South Texas Project Electric Generating Station P.O. Box 289 Wadsworth, Texas 77483

April 17, 2012
NOC-AE- 12002830
10 CFR 54
STI: 33434290
File: G25

South Texas Project
Units 1 and 2
Docket Nos. STN 50-498, STN 50-499
Response to Requests for Additional Information for the
South Texas Project License Renewal Application Aging Management Program,
Set 13 (Supplemental) and Set 15 (TAC Nos. ME4936 and ME4937)

Insert Lug at stud location #30 (all lugs on the insert have similar indentation)

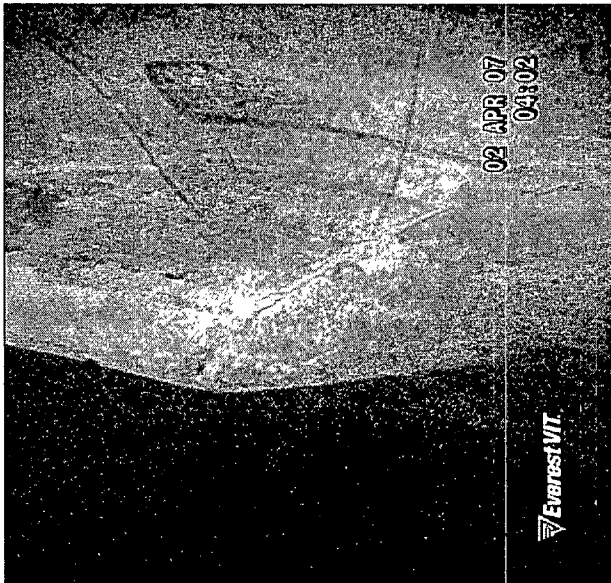
2. Describe the depth of the partially rolled areas of the stud insert lugs as the baseline information for the load bearing surface damage (5.14 in², which is 17 percent of the total load bearing surfaces of the stud insert lugs). In addition, describe the characteristics of the transition regions of the partial rolling, which are adjacent to the undamaged surfaces of the lugs, in order to assess the degree of stress concentration due to the damage.

5. Provide additional information to justify why the partially rolled lugs of stud insert #30 do not invalidate the original stress analysis results and original calculated maximum cumulative usage factor for the stud hole insert for the period of extended operation. As part of the response, provide the maximum acceptable reduction in load bearing surfaces of the stud insert lugs, which complies with the stress limits in ASME Code

ASME Code Section III, assuming the same type of lug damage observed in April 2007. In addition, compare the observed 17 percent reduction in the load bearing surfaces with the maximum acceptable reduction in the load bearing surfaces of the

2. The measured depth of the rolled indentation of the stud insert is approximately 0.005"-0.010" deep and 0.5"-0.75" wide (circumferentially). All insert lugs have similar damage. The rolled area transition is smooth to touch and is similar to the transition on the stud transition area (see attached photo). A visual inspection was performed on the stud insert and the inspector rubbed a rubber glove over the transition. The rubber glove was not damaged and did not snag on the insert damage. Therefore, it is concluded that the transition is smooth and does not have upset metal in the area.

Bottom Lugs of stud location #30
